**LAMP 1A LONDON CITY NETWORK CASE STUDY REPORTS - COVERING BRIEF**

<b>Title of Airspace Change Proposal</b>	<b>London City ACP Network Changes – Module C of LAMP Phase 1a ACP</b>
<b>Change Sponsor</b>	<b>NATS (NERL)</b>
<b>SARG Project Leader</b>	<b>[REDACTED]</b>
<b>Case Study commencement date</b>	<b>Issue 1 Received 17 February 2015. Commenced Case Study 4 March 2015 Issue 2 Received 19 March 2015</b>
<b>Case Study report as at</b>	<b>28 July 2015 V 2.1 (typos corrected 17 Sep 15)</b>

Figure 1: Proposed changes to CAS bases

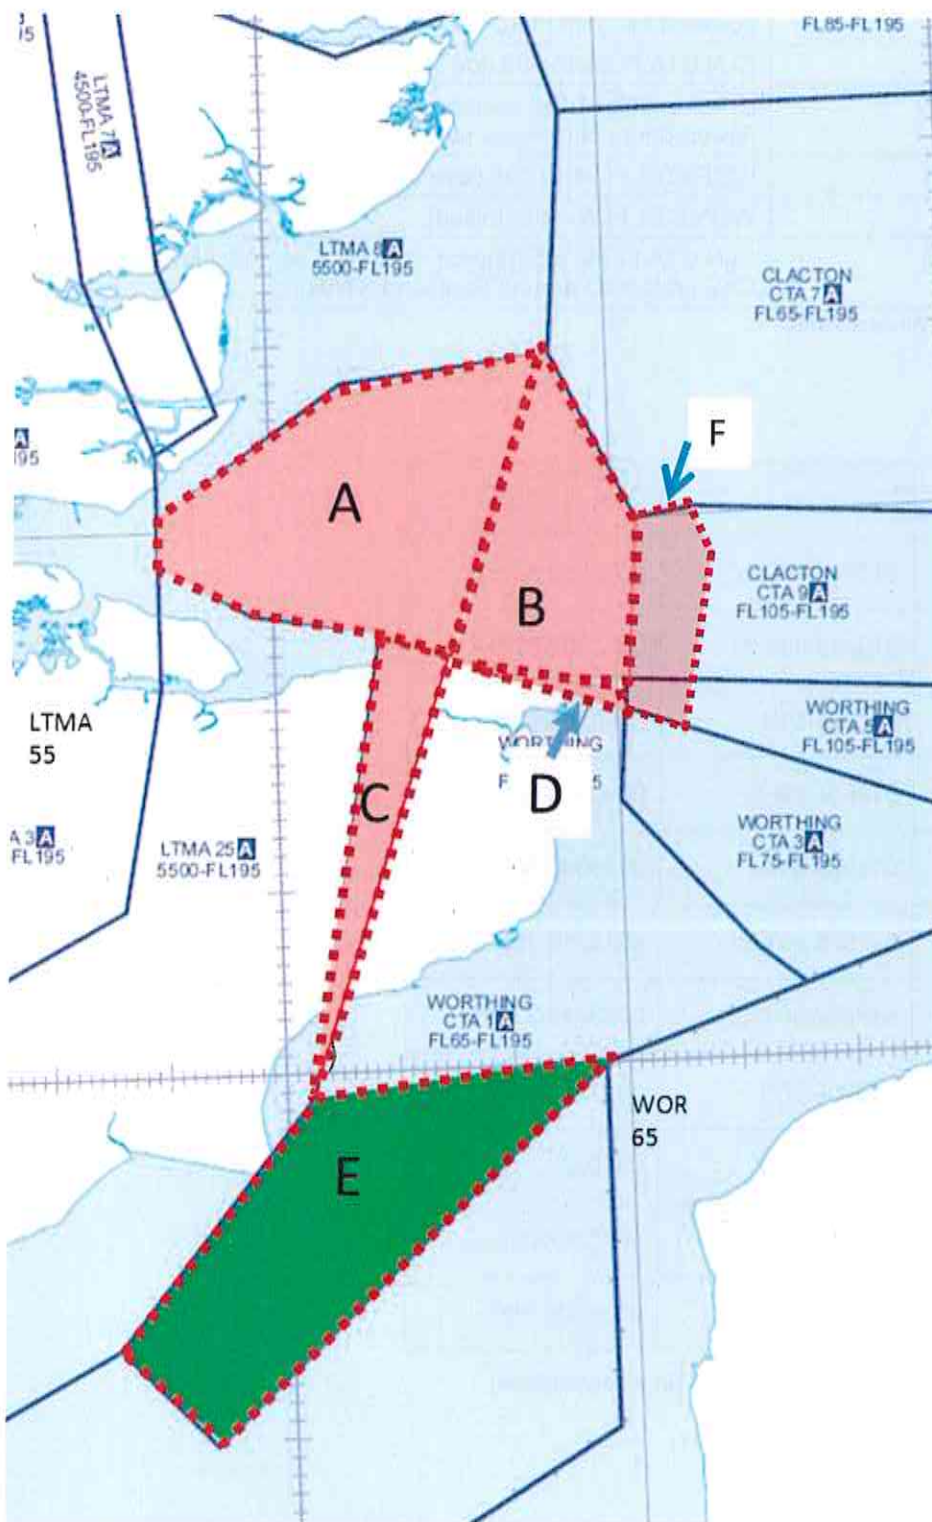
The attached document has a Figure showing the areas consulted on (labelled Areas A-D), the new area of released CAS (Area E) and the new area of additional CAS (Area F). The attached document also describes the level and purpose for all the CAS changes (Table 1), and the lat longs for the two new areas listed above (Table 2).

Aviation stakeholders are being offered a chance to provide further comment on Areas E and F to feed into the CAA assessment process because they were not covered in the original consultation. You have been sent this notification either because you are a member of the National Air Traffic Management Advisory Committee, or because your organisation provided a response to the CAS related question in the original consultation.
